PUR-1751  
ADDENDUM NO. 4  
INVITATION TO BID

HAGERSTOWN REGIONAL AIRPORT  
EXPAND/REHABILITATE TERMINAL BUILDING EAST

**DATE: Friday, June 20, 2025**

12  
A2.4  
HEAD DETAIL @ SLOPED GLAZING  
1 1/2" = 1'-0"

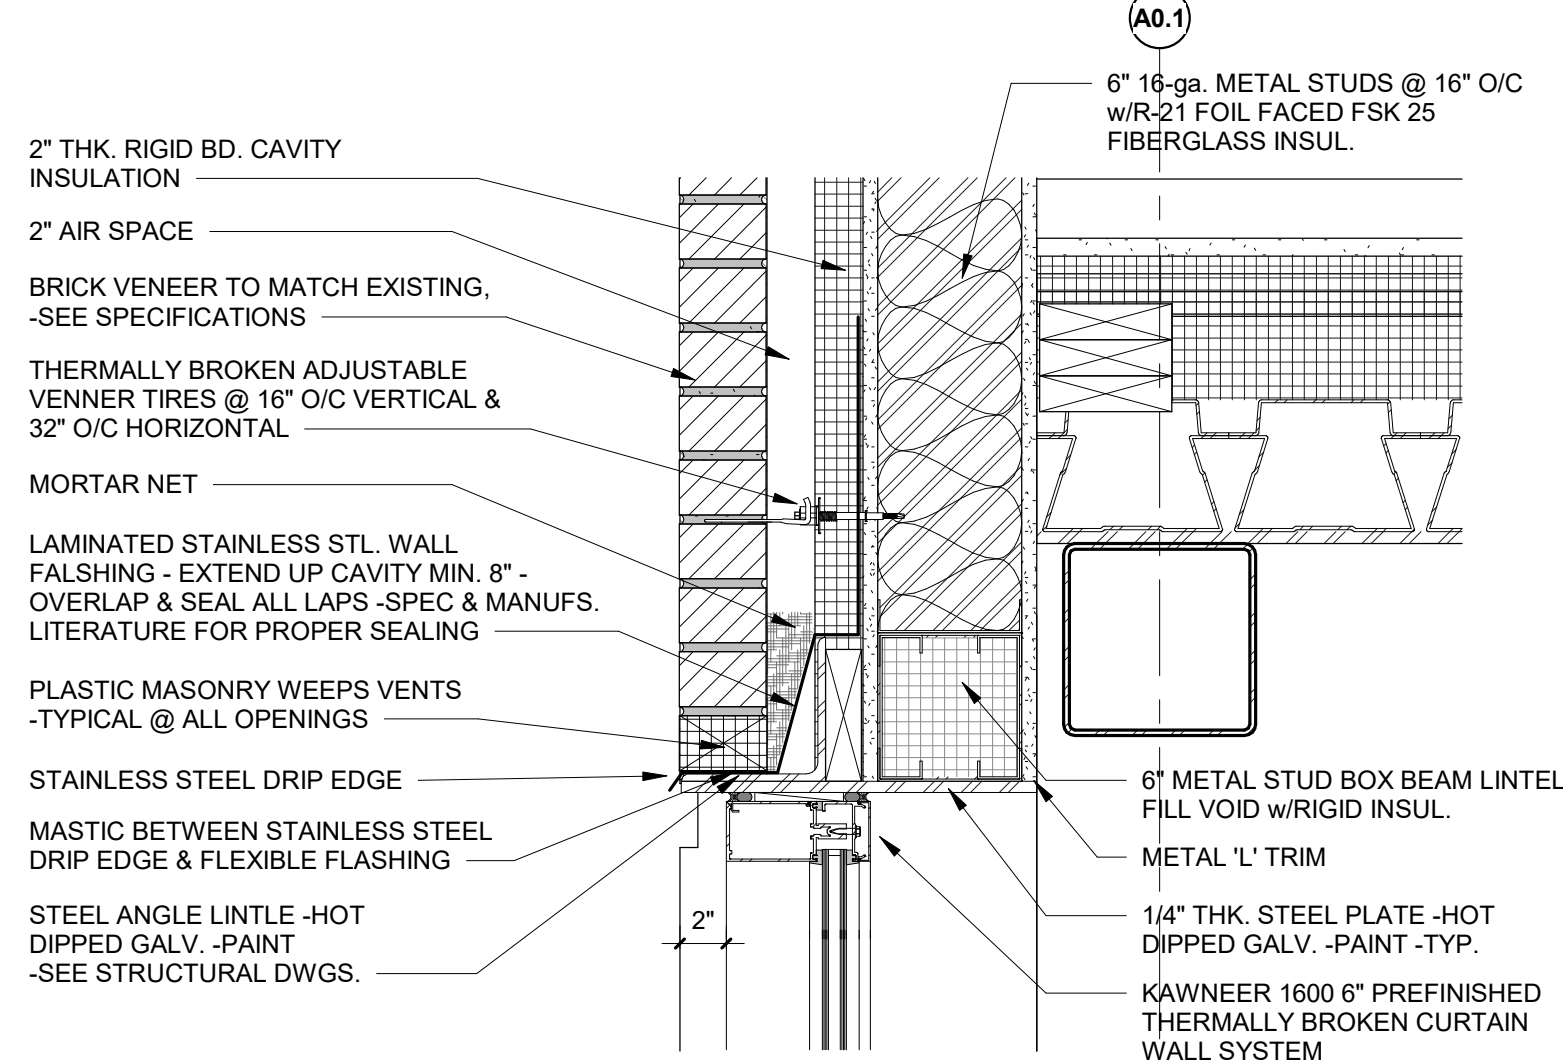
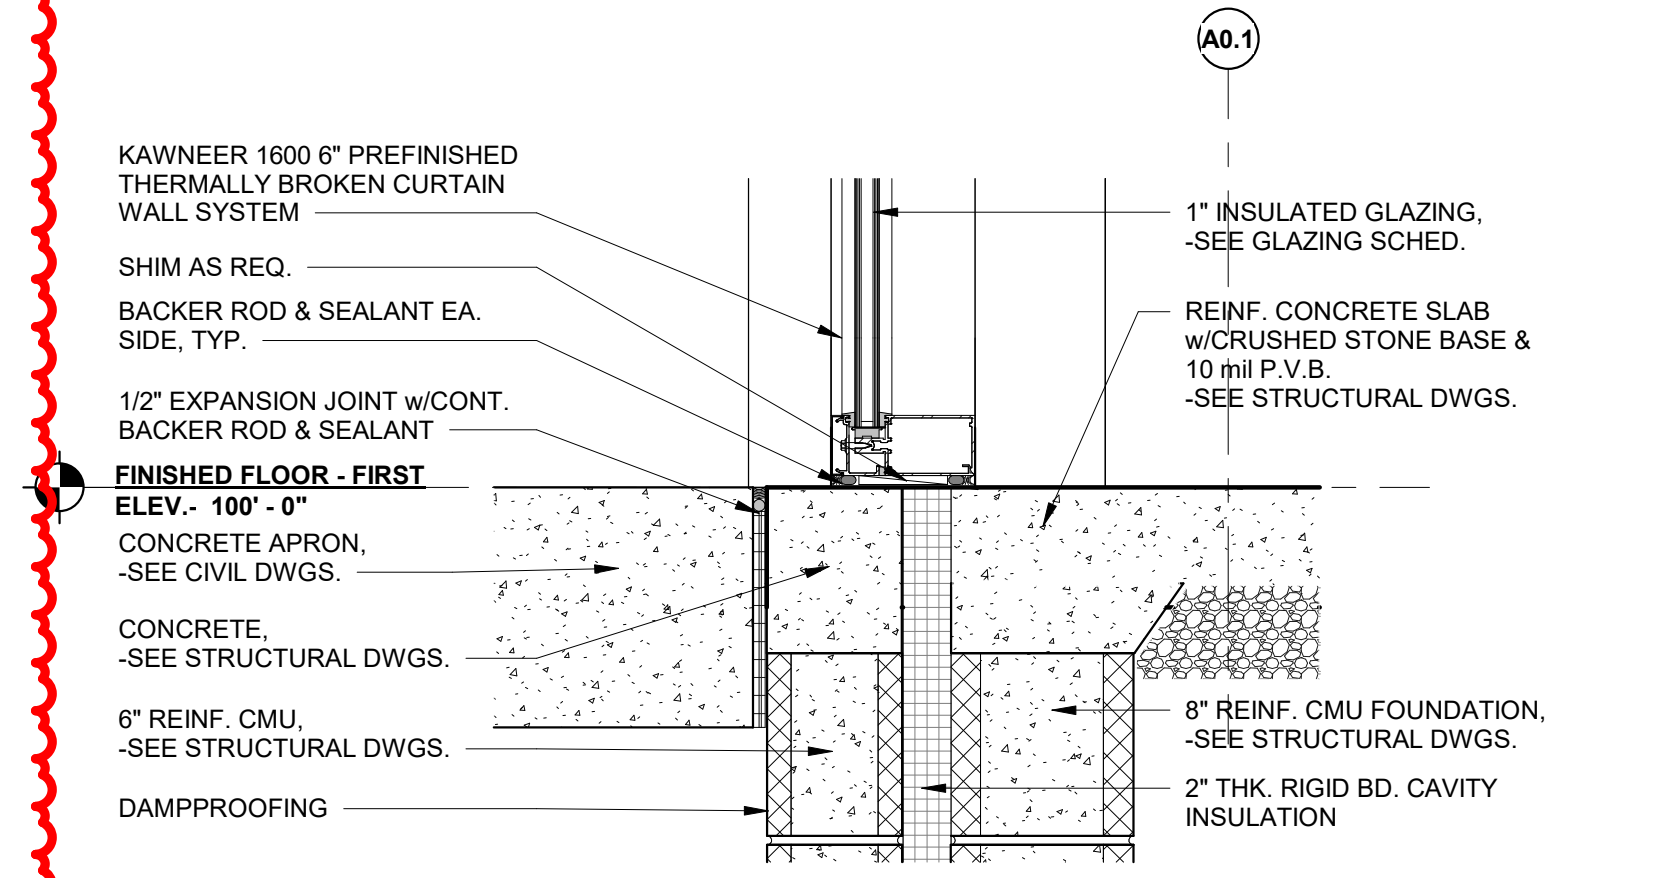
**ITEM NO. 6:** Inquiry: Sloped glazing assemblies above rooms 117 and 118 are not shown on the window types drawing A2.2. Please provide.

Response: DELETE Drawing A2.4 in its entirety and REPLACE with Revised Drawing A2.4, dated 06.18.25. Sloped glazing system is shown on Drawing A4.5 with details on Drawing A2.4. Provide 3/8" polycarbonate glazing. (Attachment A)

1 ENLARGED FIRST FLOOR PLAN - POWER & DATA  
E3-1 1/8" = 1'-0"

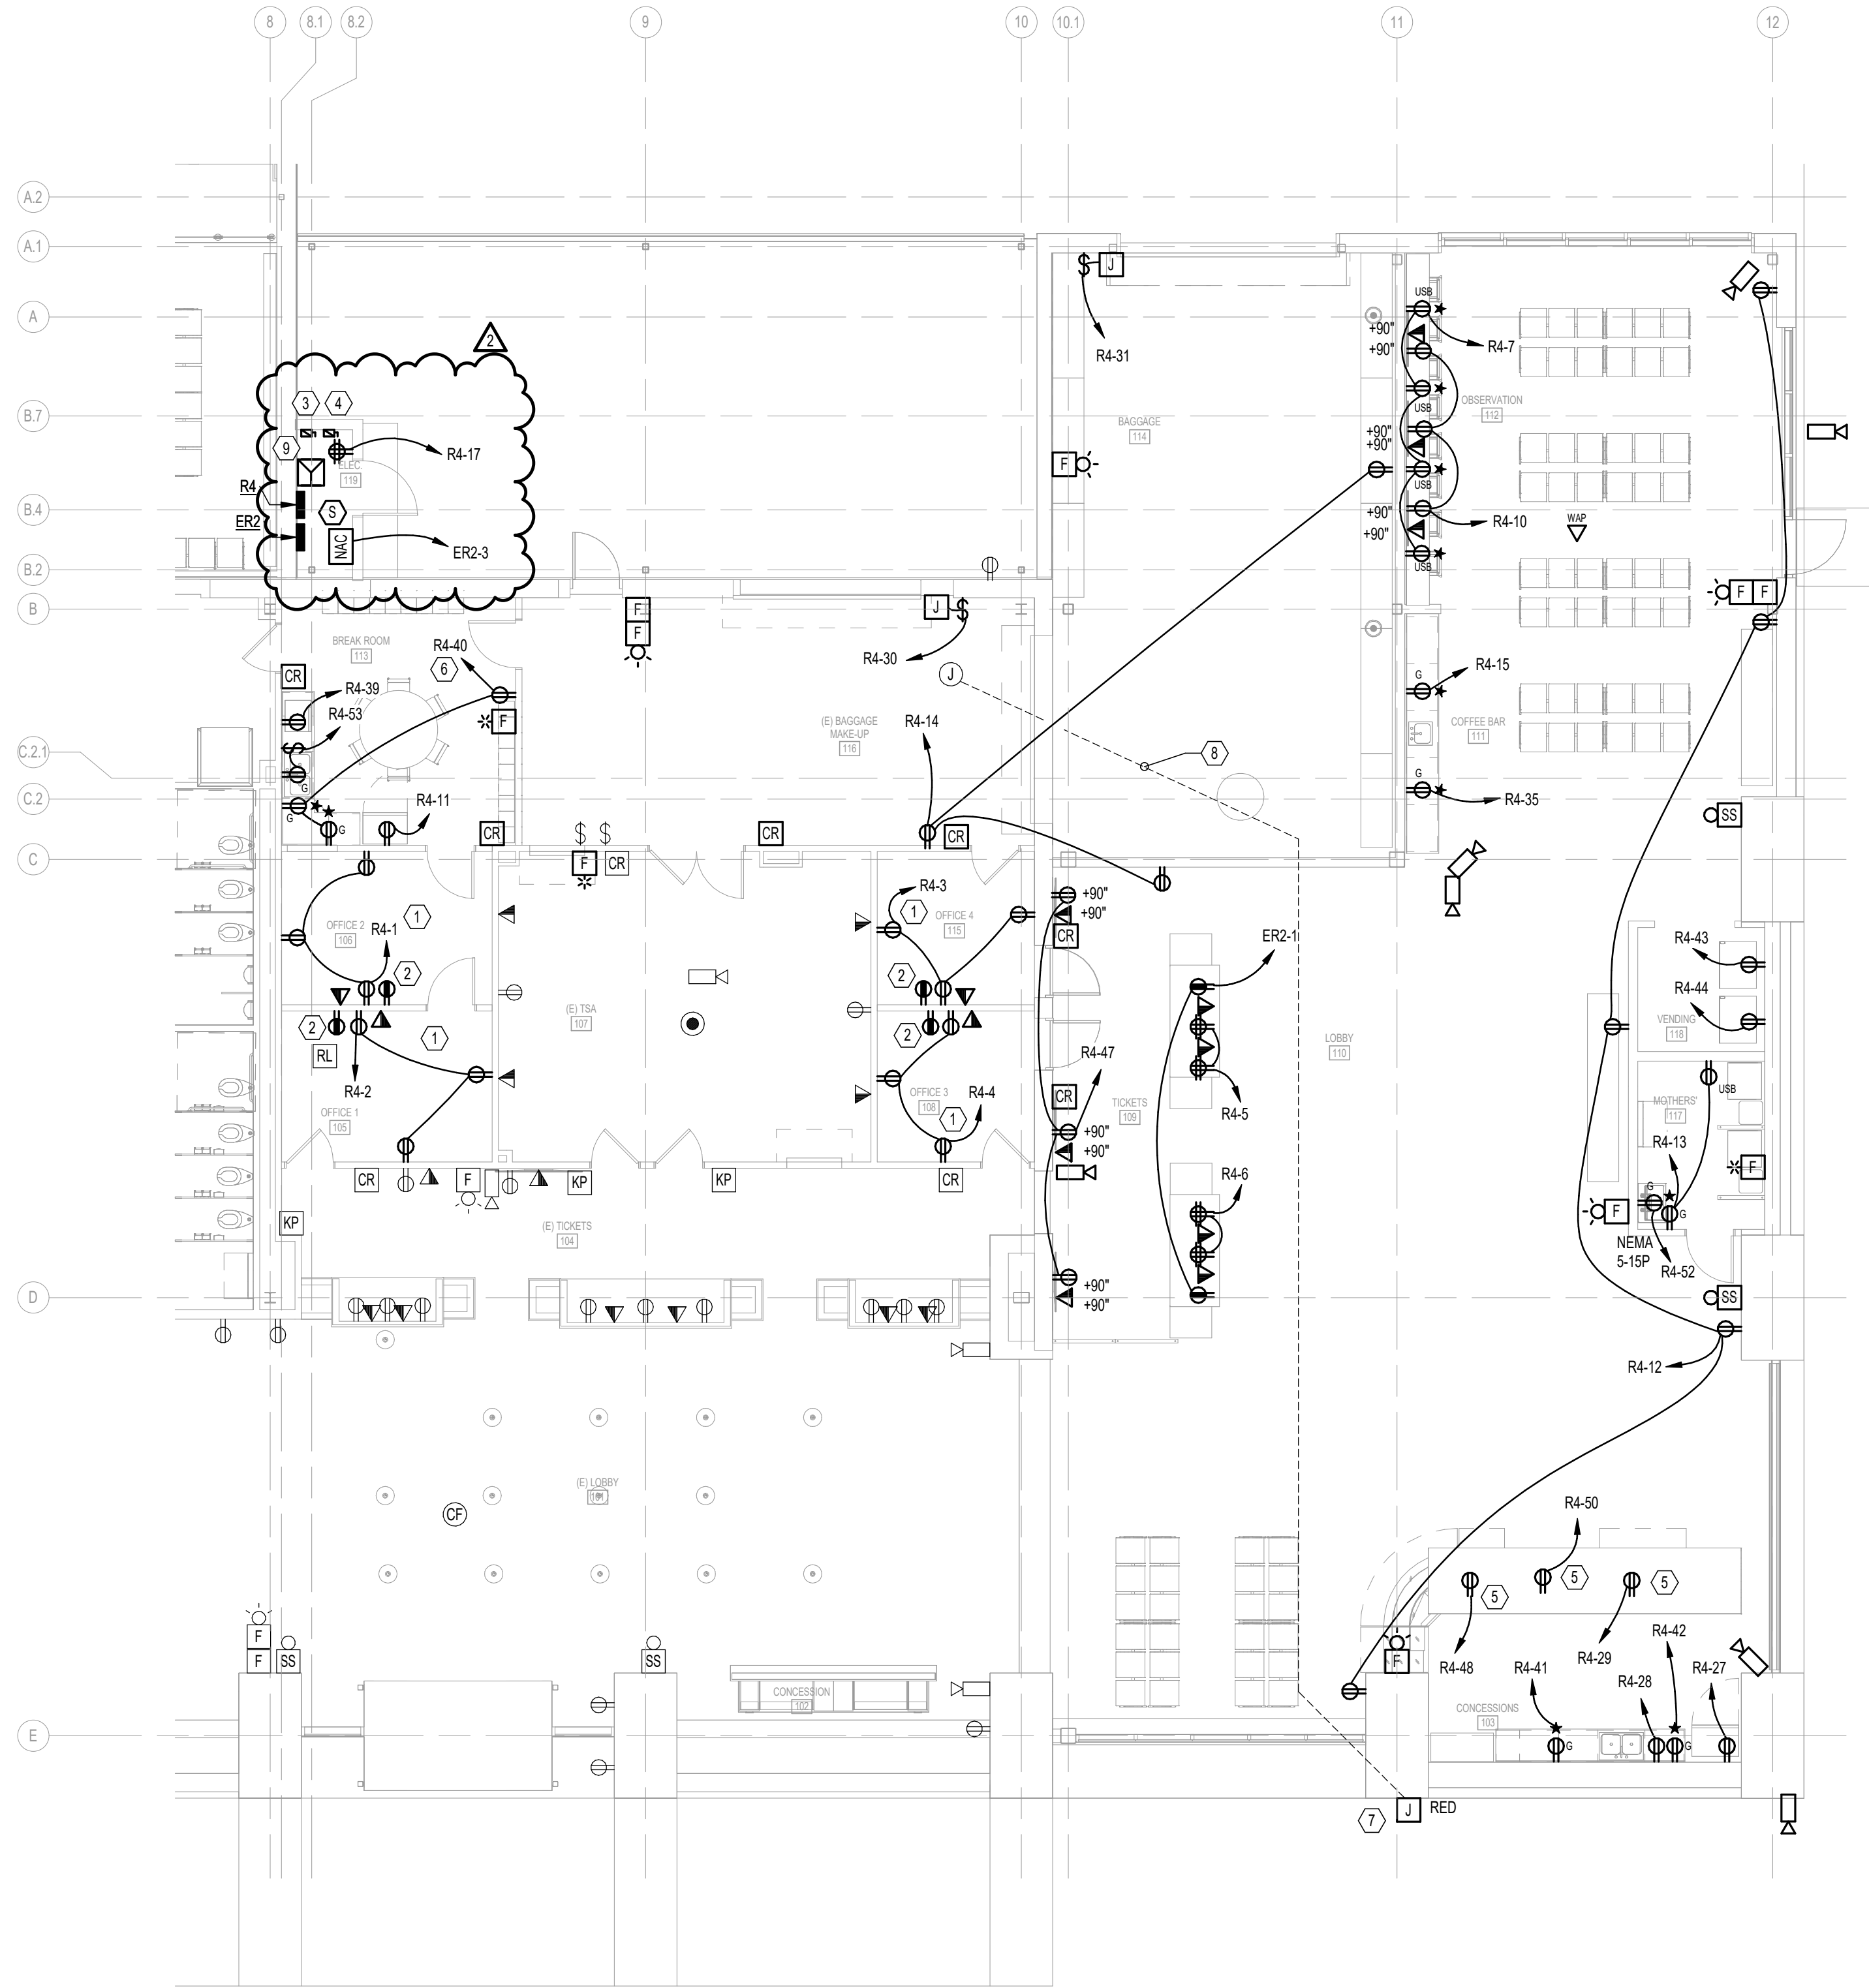
**ITEM NO. 22:** Inquiry: Ref.: Electrical room orientation: During site visit the Designer mentioned that the 2 new transformers will be stacked rather than floor mounted. Please confirm and provide an updated drawing.

Response: Refer to Addendum 4 Drawing Revisions for updated transformer layout.

- EXTEND EXISTING 2" CONDUITS AS REQUIRED FOR RELOCATED FIBER CABLING TO EXTERIOR GATE.
- 15KVA TRANSFORMER STACKED OVER 45KVA TRANSFORMER.
